Administrative Approval Action

SR-34-18 /Cardamom Market
Transaction# 550857 AA# 3877

REQUEST: Development of a .42-acre tract zoned CX-3 into a 3,941 square foot building with retail grocery & restaurant/bar.

Design Adjustment Staff Response

SK-100
BLOCK PERIMETER

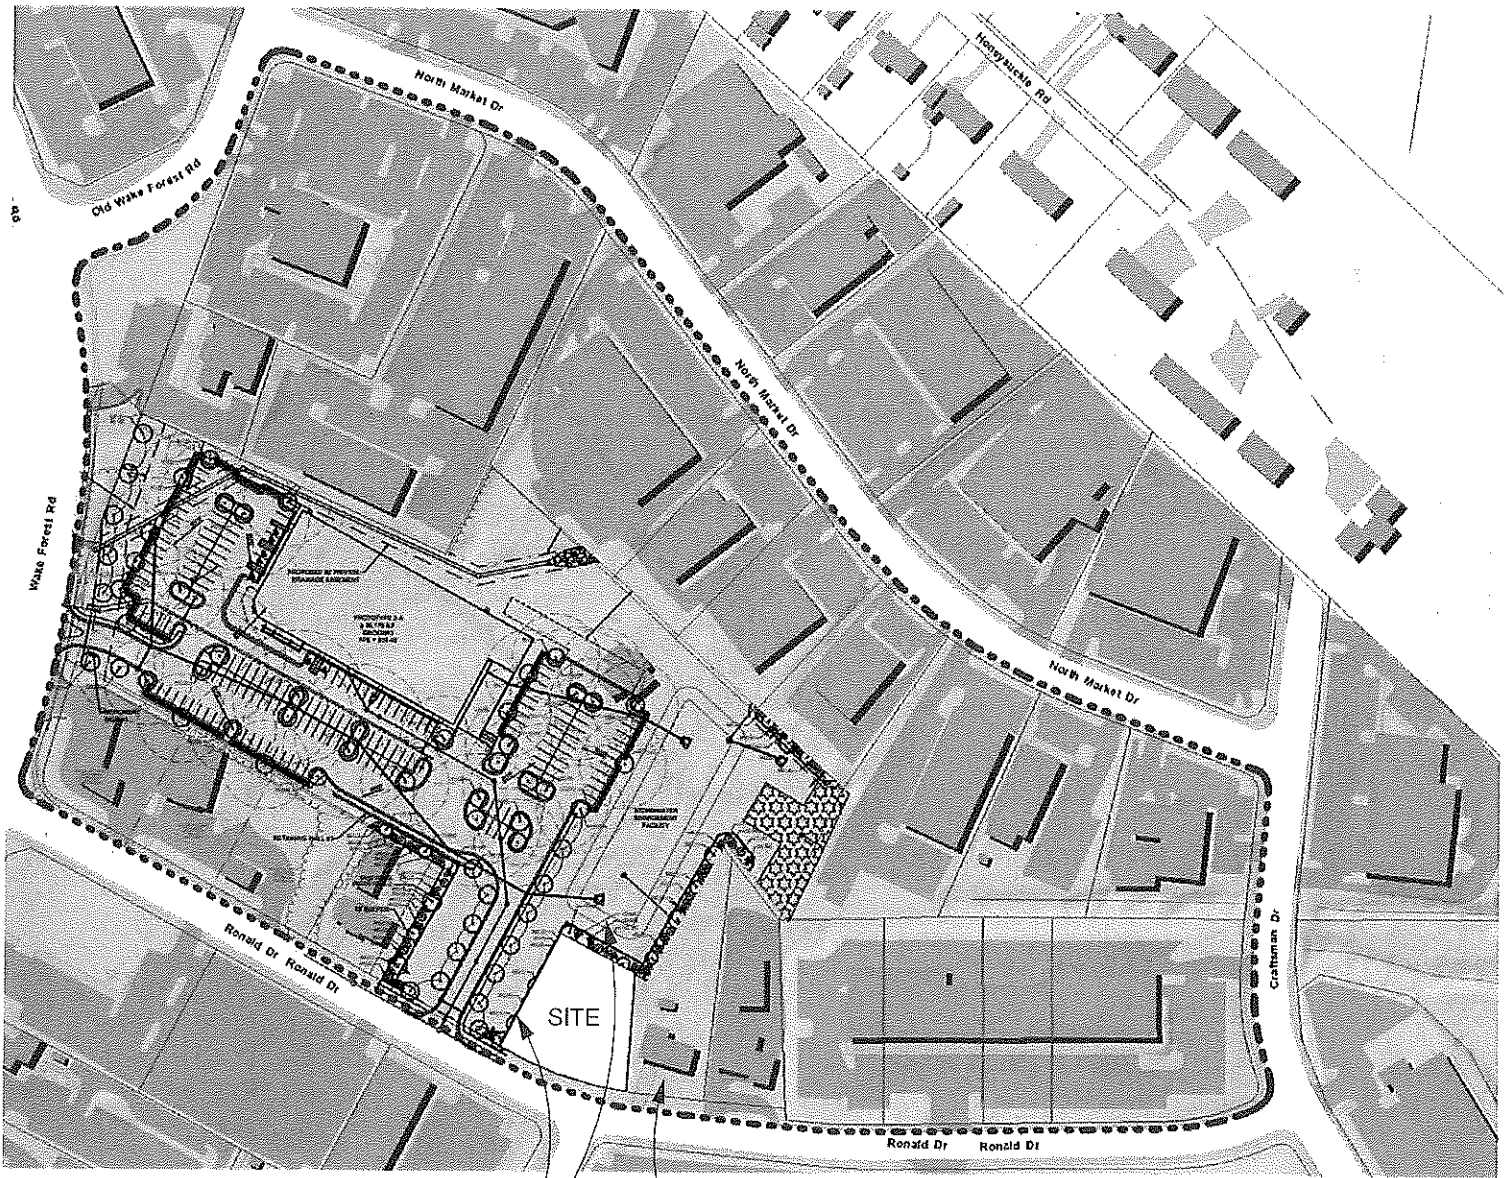
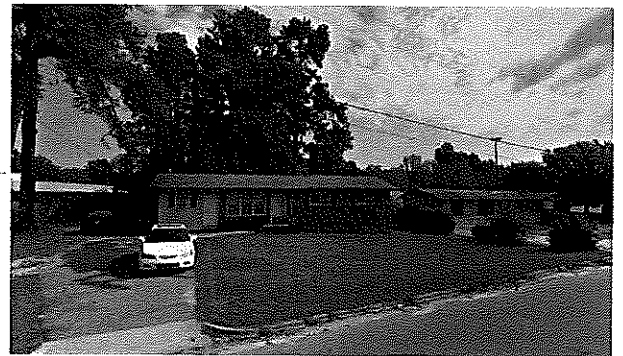
The maximum block perimeter for CX-3 zoning is 3,000 linear feet per UDO Article 8.3 and the existing measurable block perimeter is 4,364 linear feet as per the attached exhibit. This lot is adjacent to a 7-acre new development to the north and west of this site which will prohibit any street connection from Ronald Drive to the north that would be of a benefit in reducing the block perimeter. Staff is in support of a waiver from the block perimeter requirements.

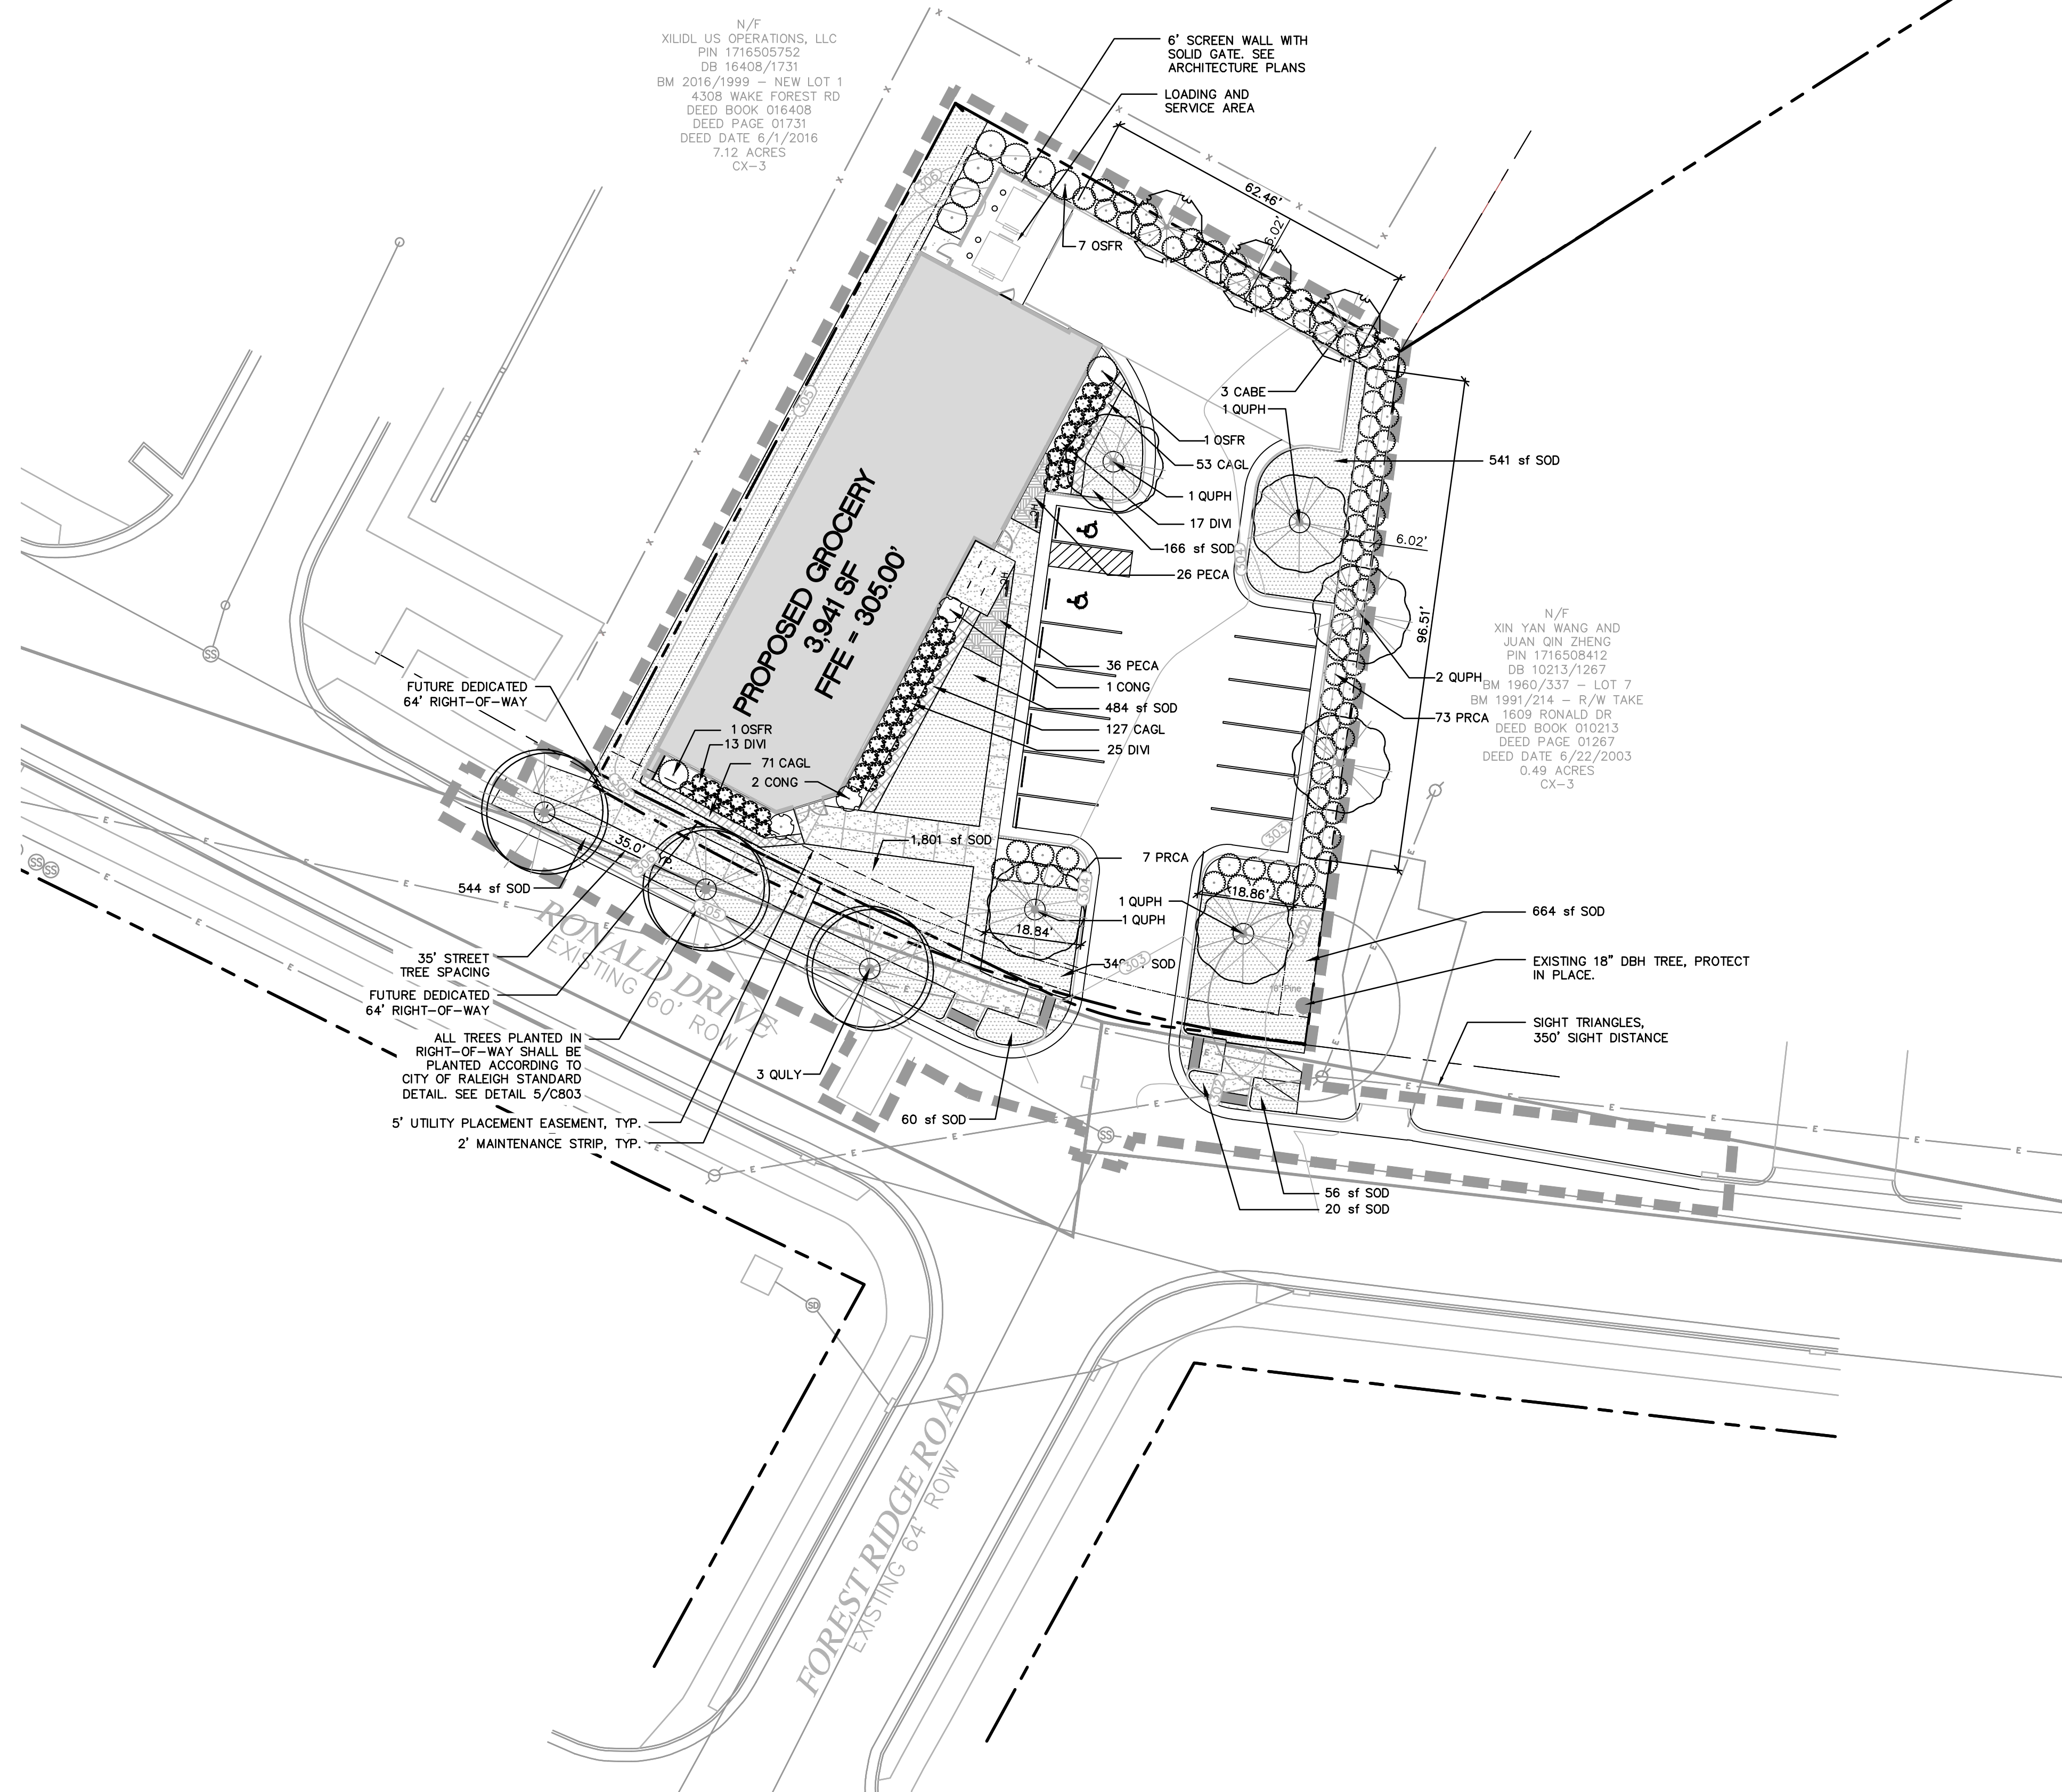
3. Show the 3 shade trees in the right-of-way on plan sheet C-700.
